Design Review Subcommittee (DRSC)

Meeting Date: November 29, 2023

SUBJECT: **Development Permit (DP) 23-416, Bauder Addition,** a request for a 603 square foot 2nd story addition and balcony addition to an existing single family residence located at 106 W Paseo de Cristobal within the Residential Low Zone and Coastal Zone Overlay (RL-CZ) adjacent to a historic structure located to the northeast of the subject property.

PROPOSED ELEVATIONS

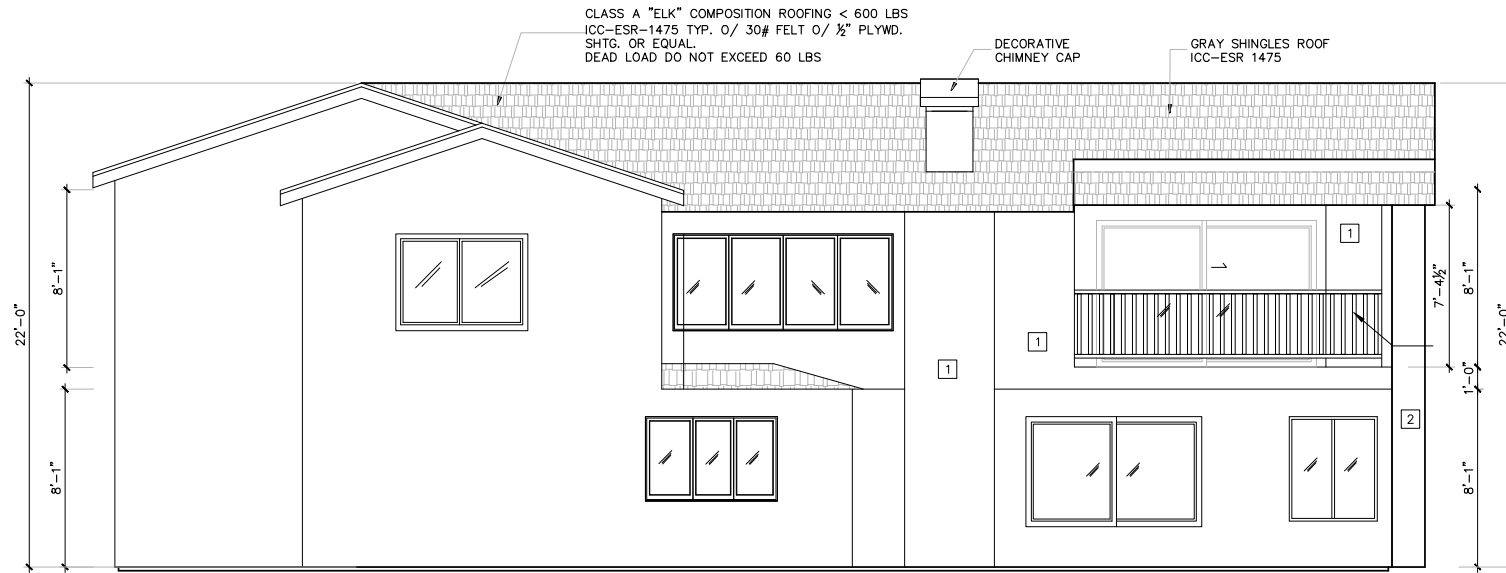
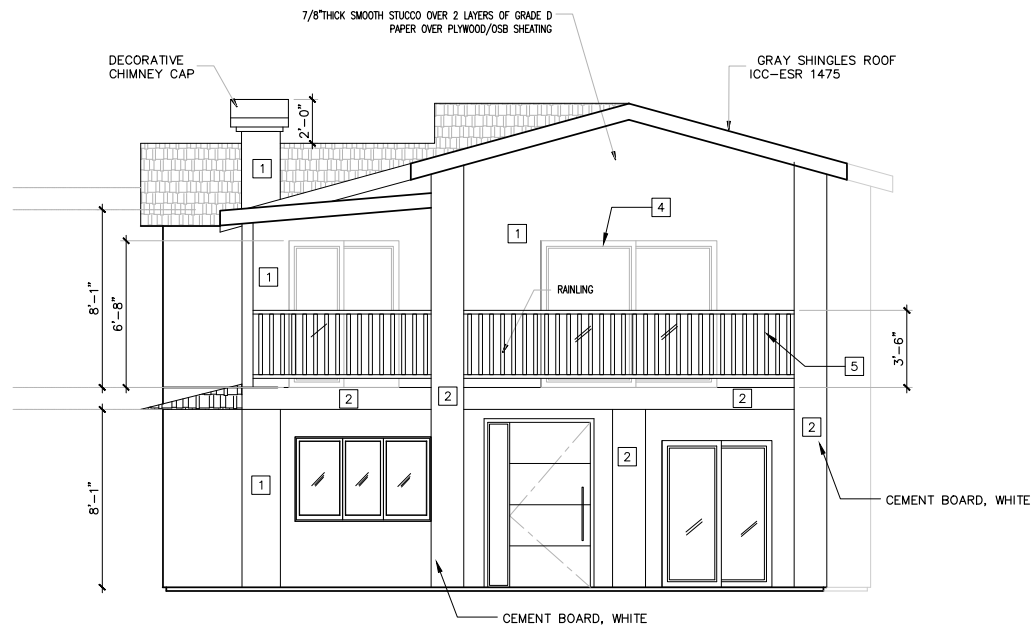
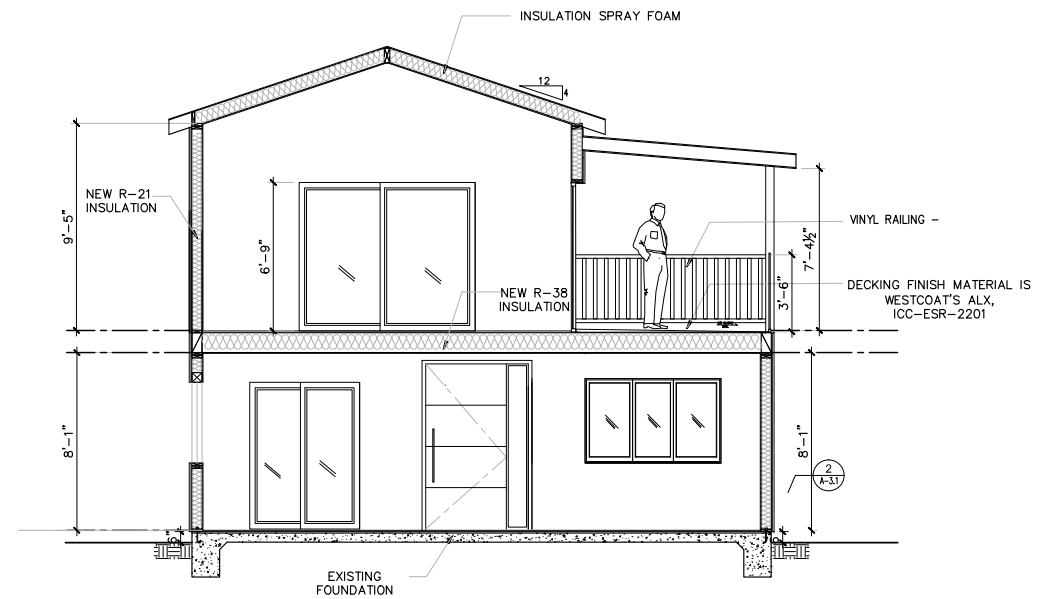
therefore will maintain a higher peak elevation, further helping to separate and differentiate the two properties. An architectural style for the subject property has not been defined. Staff recommends that the applicant choose an architectural style to guide the project in the selection of materials and architectural elements for a cohesive design that is sensitive and complementary to the historic resource. Since the project does not include a third story above the addition, the width of the columns on the front wall plane is disproportional and should be reduced [reference sheet A-3.1, note 2 callouts]. To address this, staff recommends the following options: 1) provide a solid gable end, and potentially keep thick columns; 2) reduce the width of the columns; or 3) provide gable brackets along with either option 1 or 2. The intent with these options is to visually ensure the columns appropriately support the overhead weight, consistent with design guidelines.

1. Choose an architectural style for the proposed project. The current style is difficult to define, which makes it difficult to provide a clearer direction or recommendations for the building. The DRSC may have recommendations that help to identify a style.
2. Propose a different column material other than stucco, in order to provide variation of materials in the front elevation.
3. Since the project does not include a third story above the addition, the width of the columns on the front wall plane is disproportional and should be reduced. To address this, staff recommends the following options:
 - a. provide a solid gable end, and potentially keep thick columns;
 - b. reduce the width of the columns; or
 - c. provide gable brackets along with either option "a" or "b" above.
